Product Change Notice (PCN)

PCN Number: PCN-0460231R-01 **To Our Customers:**

Product(s) Affected: TB009-508 series

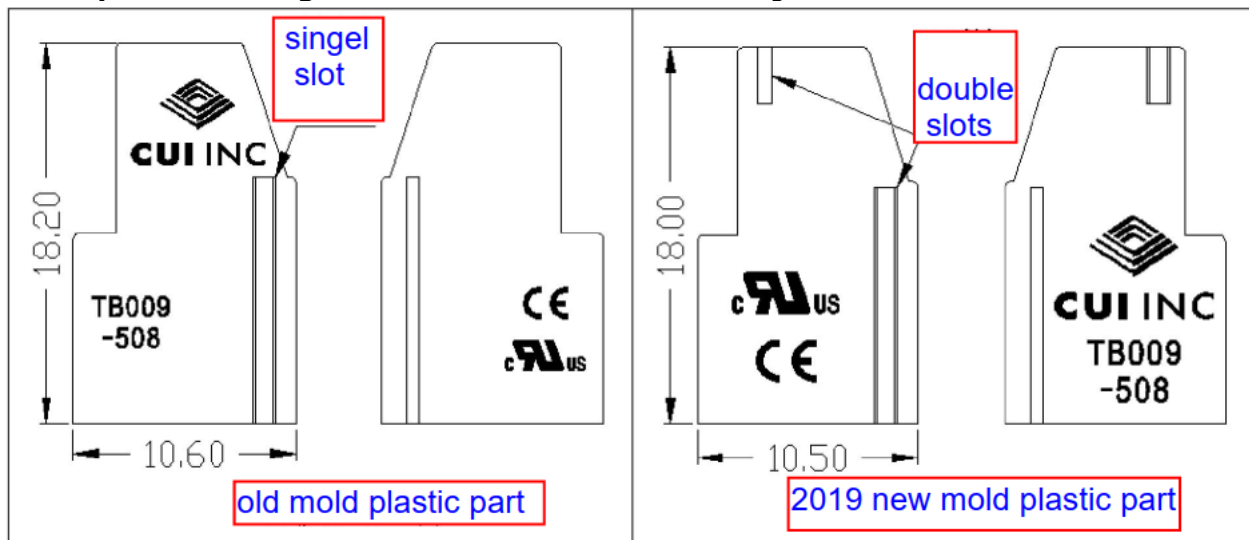
Description of Change: Additional slot for ease of configuration as shown below:

Additional Information: Products using the old mold cannot be connected to products using the new mold.
